Subject: Data Response, Set 2A
Hidden Hills Solar Electric Generating System (11-AFC-2)

(11-AFC-2)

Hidden Hills Solar Electric Generating System (HHSEGS)

**Data Response, Set 2A
(Response to Data Requests 136 through 143)**

FIGURE DR137-3
General Plan and Zoning for Inyo County
 Solar Plant Alternative Site, Inyo County
 Hidden Hills Solar Electric Generating System

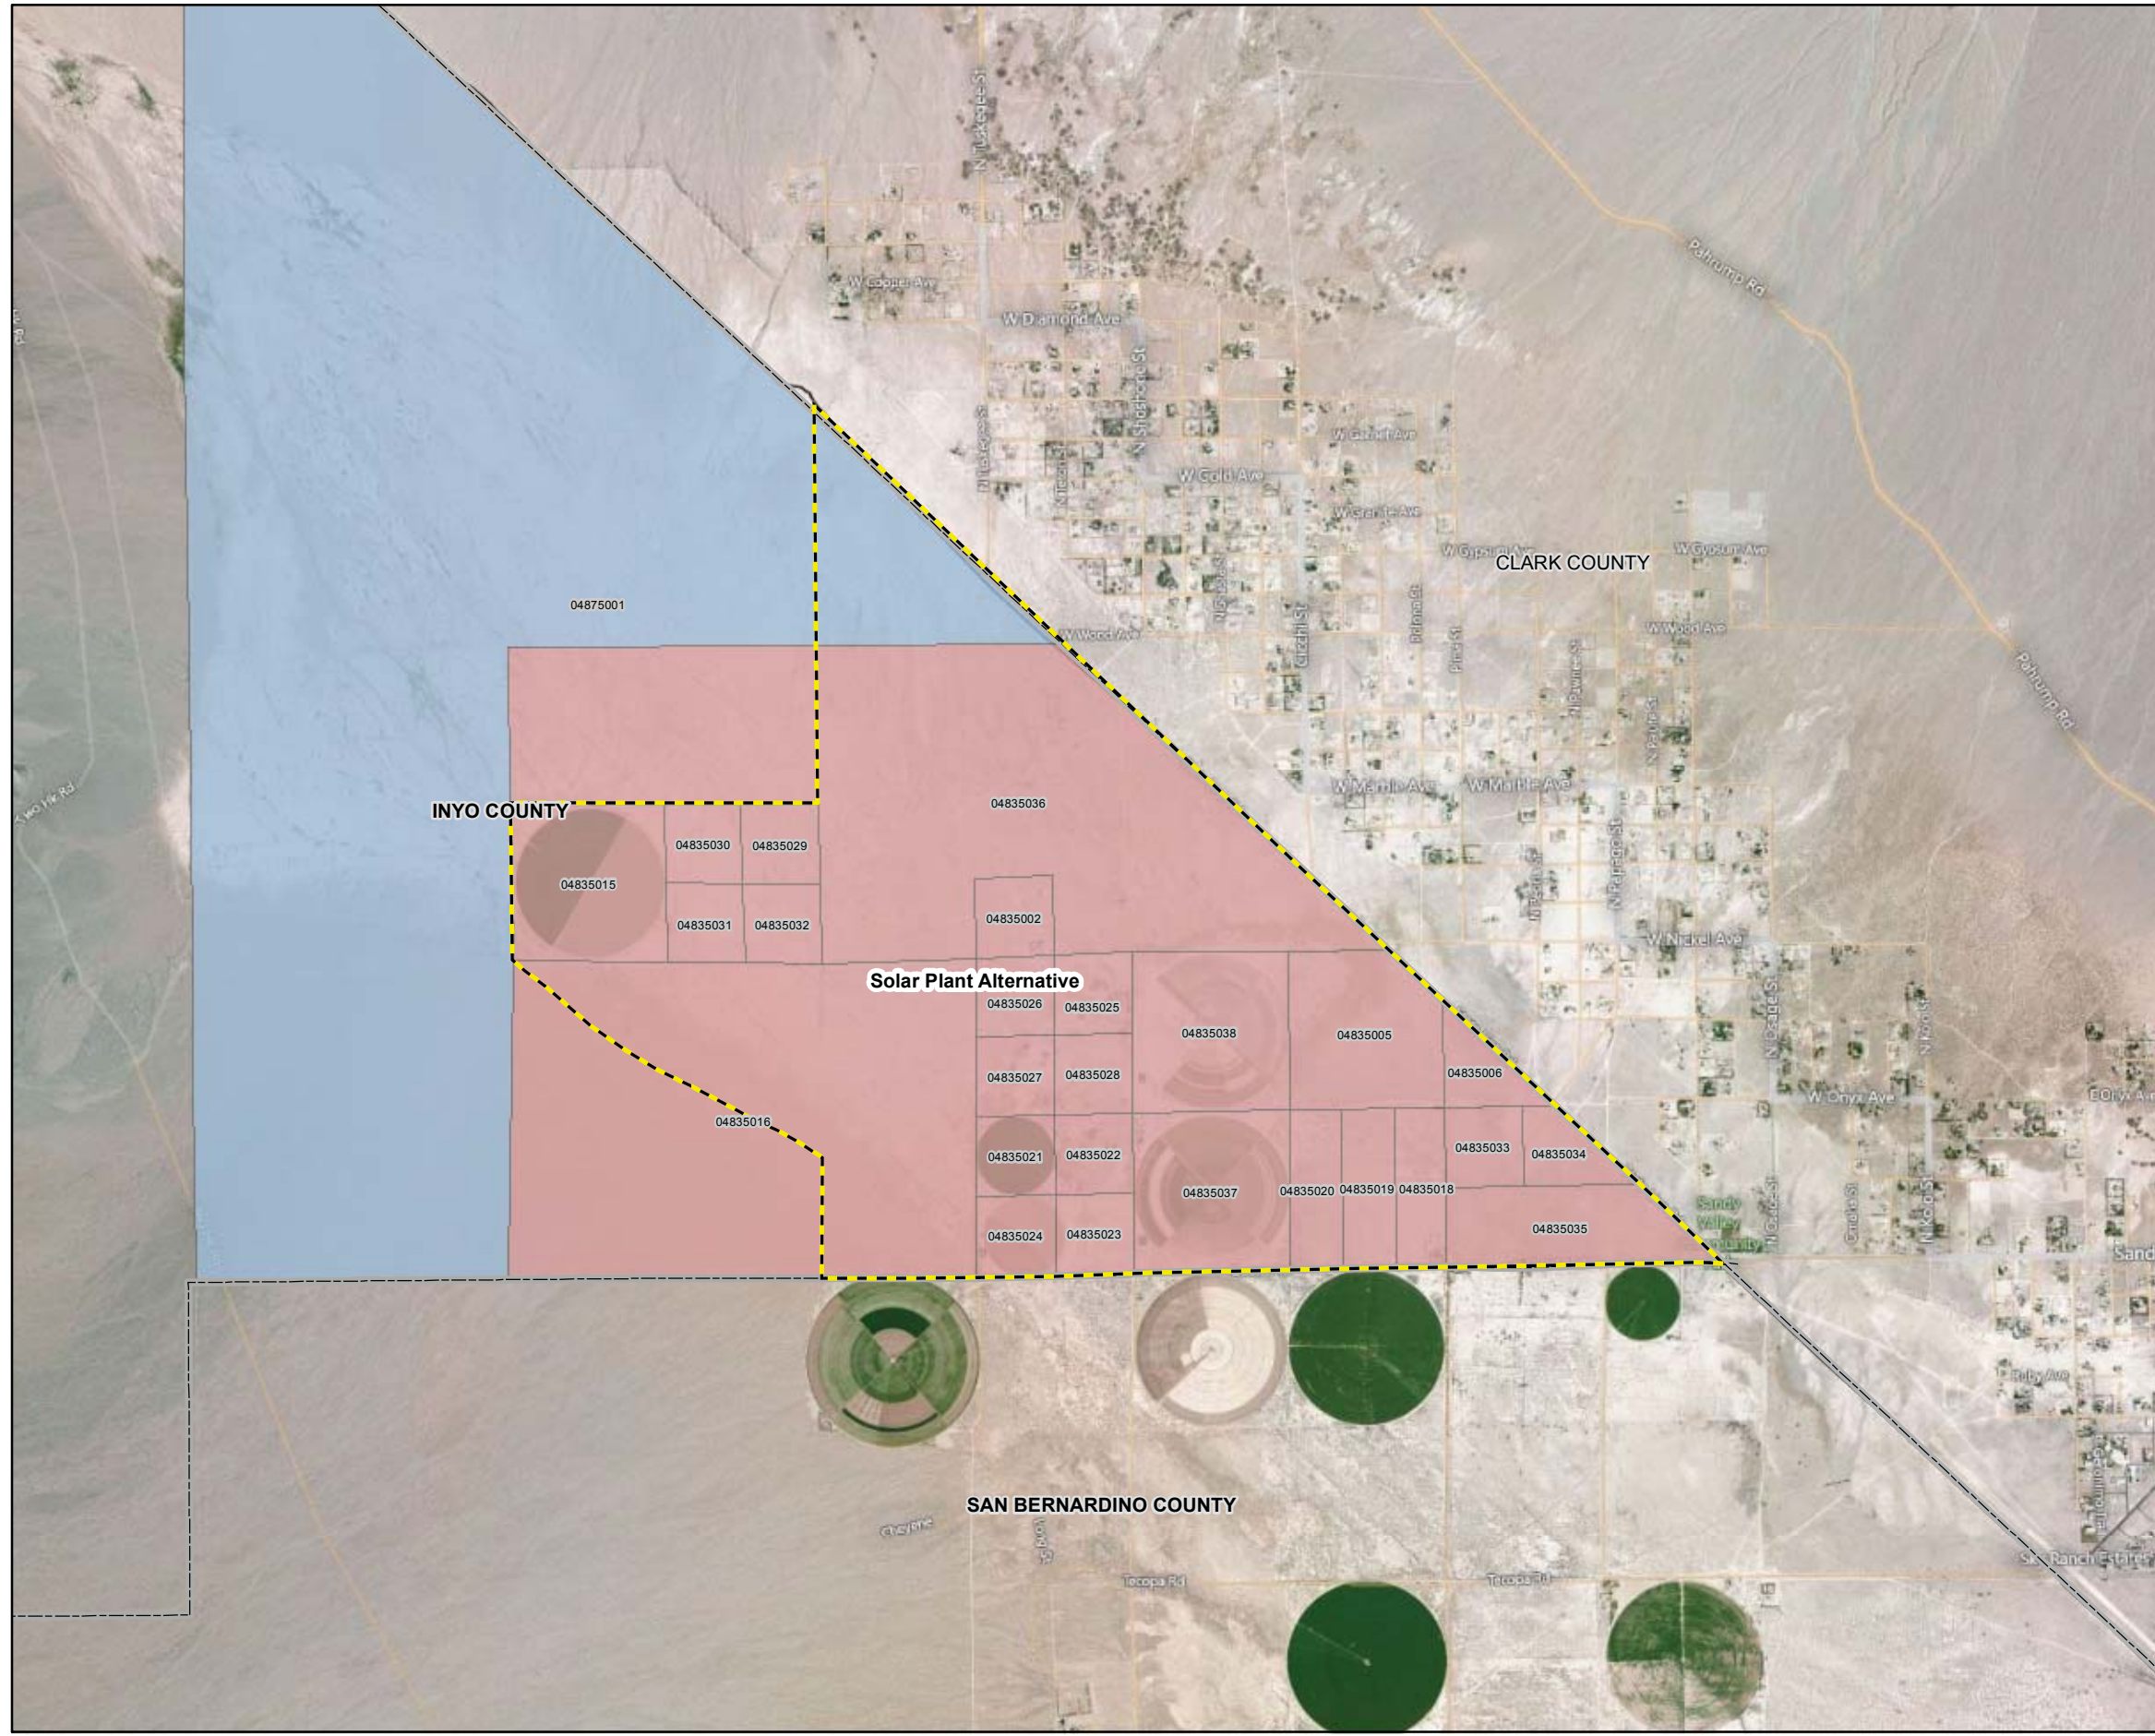
- d. Information on Inyo County's general plan designation and zoning for private land in the area. *Please confirm the accuracy of the information provided in the data response on Inyo County's designated land use and zoning district for the area. Include information on San Bernardino County's general plan designation and zoning for private land in the area.*

Response: The HHSEGS site is located entirely on privately held lands and is therefore not subject to conformance with BLM land management policies. For the Solar Plant Alternative site, as shown on Figure DR137-3, the northern portion of the site is in an area that includes federal lands. The portion of the site comprised of federal lands would be subject to the BLM's plan for the Northern and Eastern Mojave Planning Area. Therefore, placing a solar project in the Solar Plant Alternative site would likely require an amendment to that plan.

Response: Figure DR137-3 identifies the general plan and zoning designations for the Solar Plant Alternative. Under the Inyo County General Plan, the Solar Plant Alternative site is designated either as Agriculture or State and Federal Lands. Additionally, Policy LU-1.6 of the Inyo County General Plan provides that the County shall preserve agricultural and related open space uses on private lands and will not designate additional land for rural residential development. The zoning for the Solar Plant Alternative site is mostly Open Space (OS-40).

FIGURE DR137-9
USGS Tortoise Habitat Model
 Solar Plant Alternative Site, Inyo County
 Hidden Hills Solar Electric Generating System

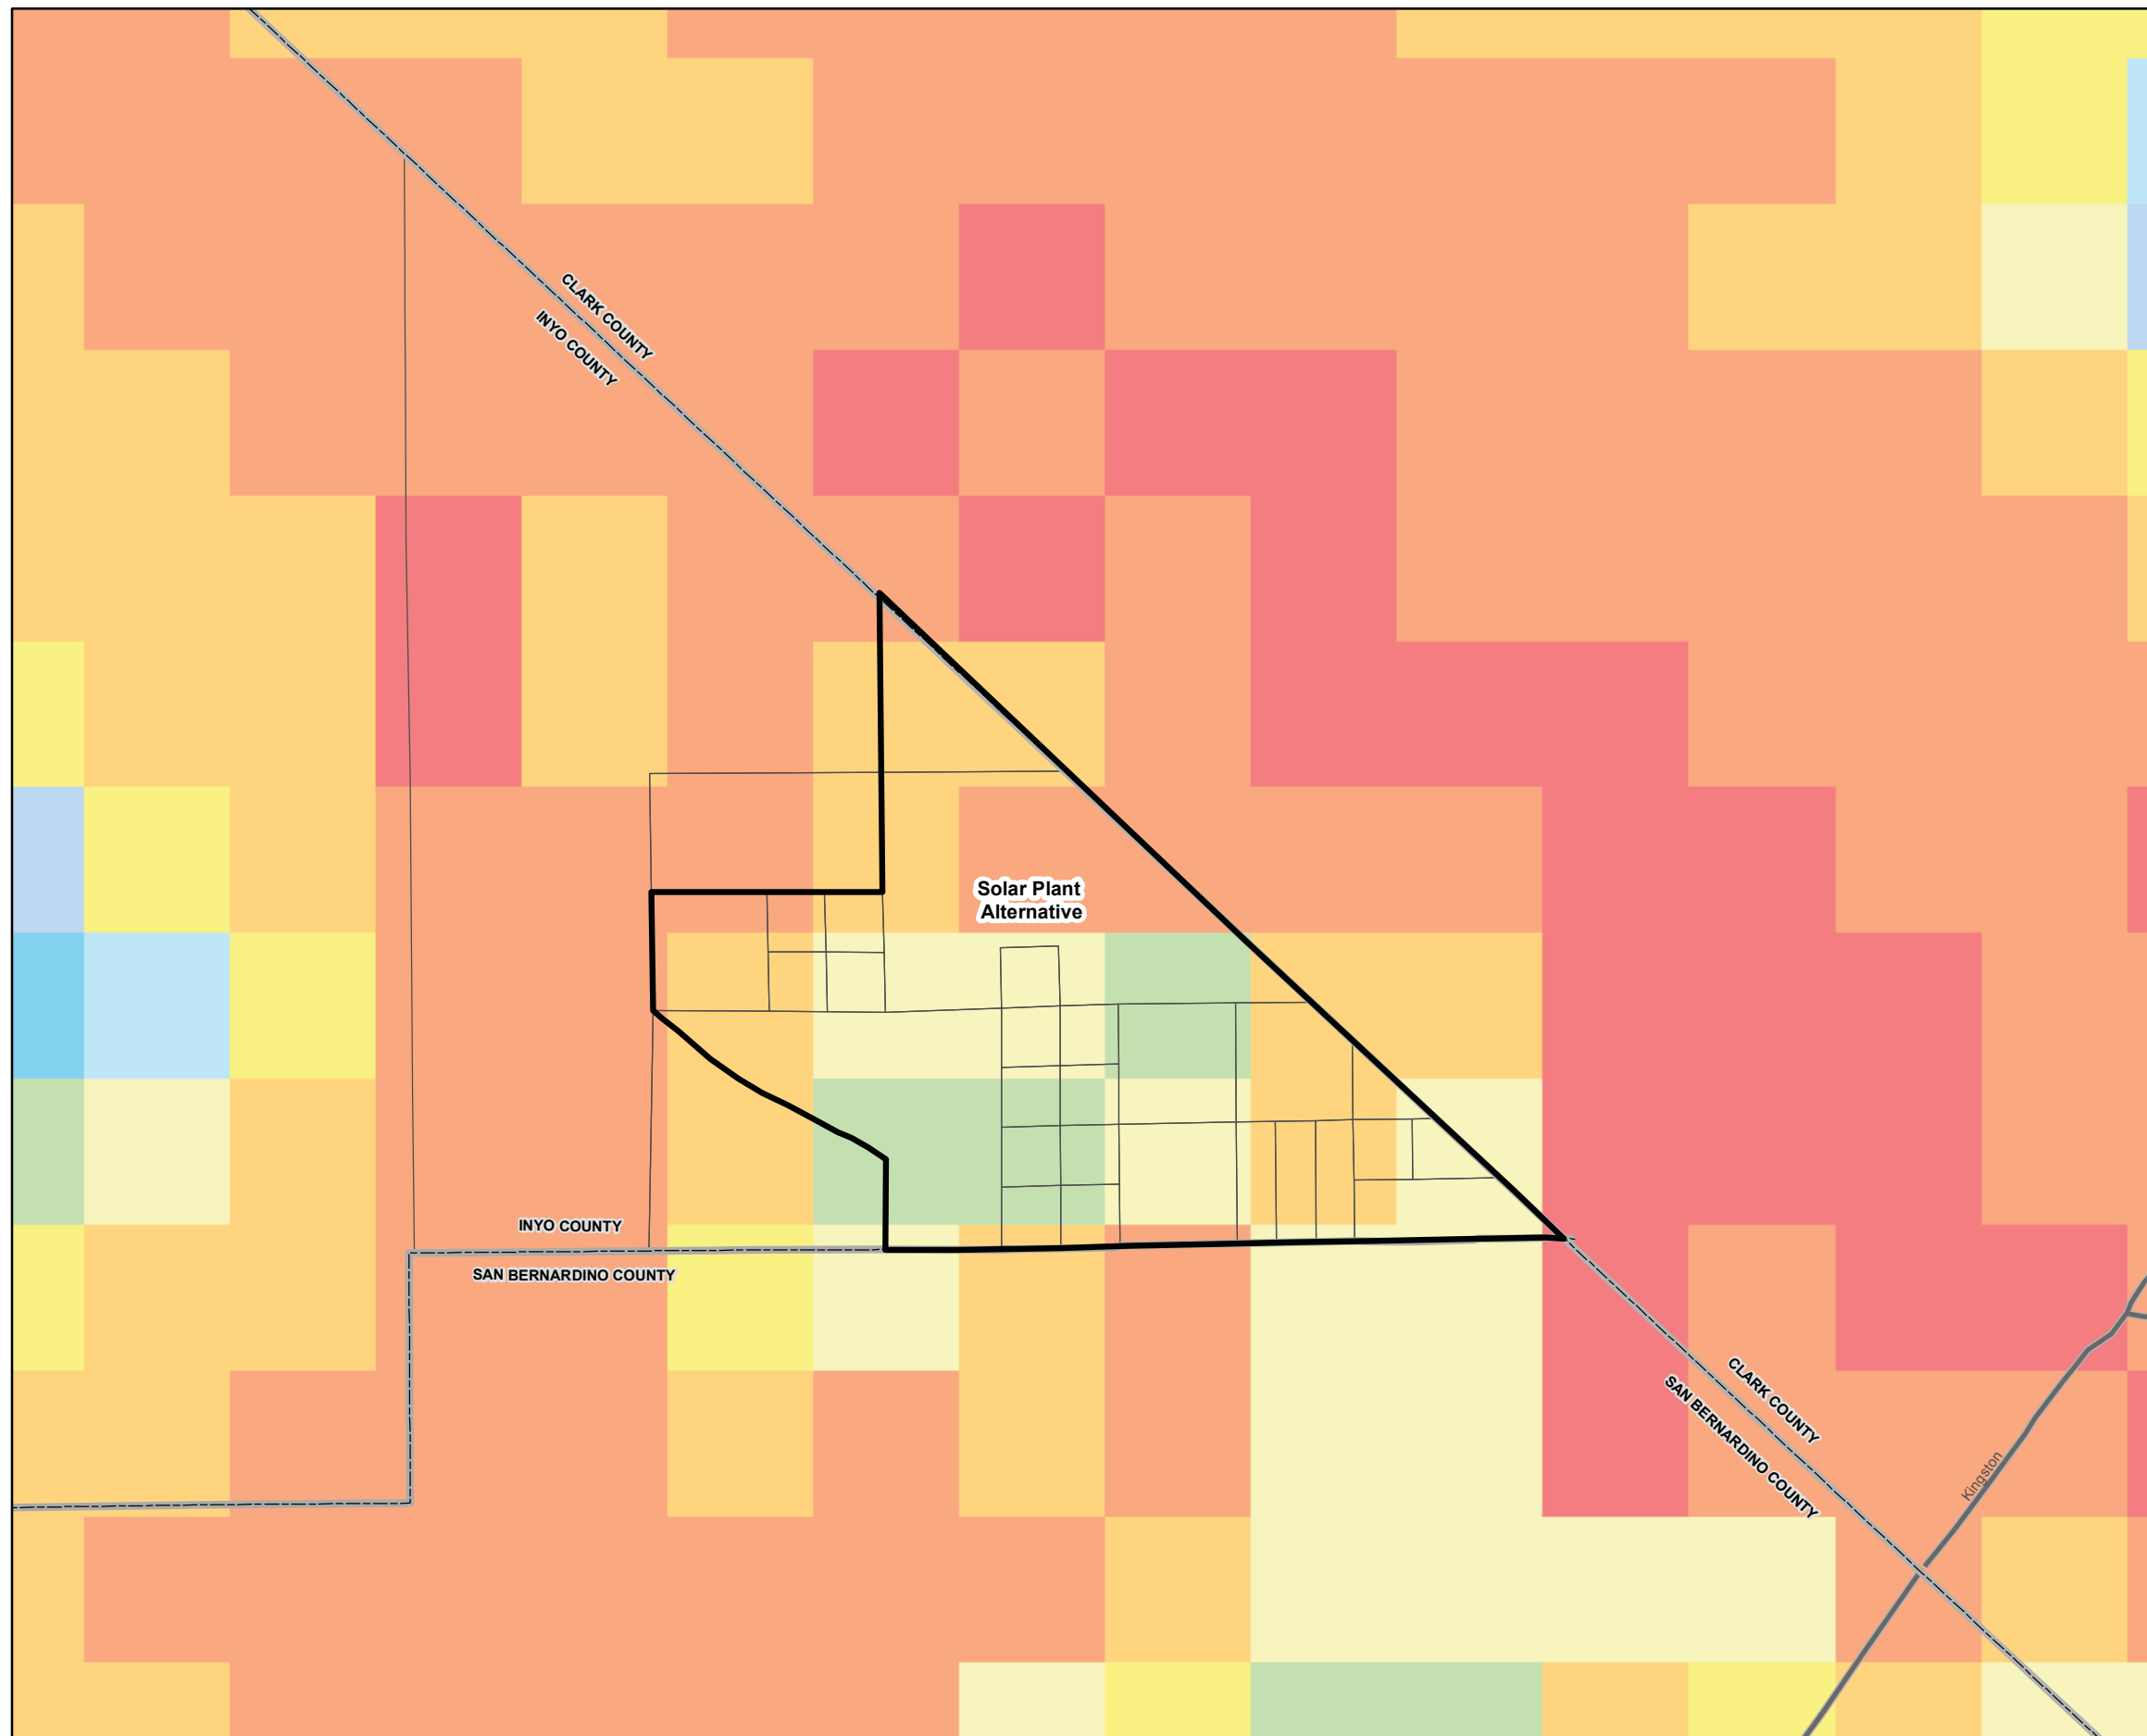
- l. Information on habitat types and protected plant and wildlife species that could be present in the area. Include data obtained from a California Natural Diversity Database record search for the area.

Response: Figure DR137-9 shows USGS desert tortoise habitat model results in the vicinity of the potential project alternative. In addition, Figure DR137-10 shows the results of a CNDDDB record search for a 10-mile radius from the site. The Solar Plant Alternative site is located in an area depicted with some suitable habitat for desert tortoise. Figure DR137-10 shows that some special-status plants have also been reported in that portion of the valley. However, with the presence of the current land uses, presence of desert tortoises and special-status plants on the privately owned parcels is less likely. However, they could be present on the BLM-managed lands. With the implementation of mitigation measures, and in compliance with state and federal endangered species act requirements, impacts to desert tortoise and any special-status plants would be mitigated to acceptable levels.
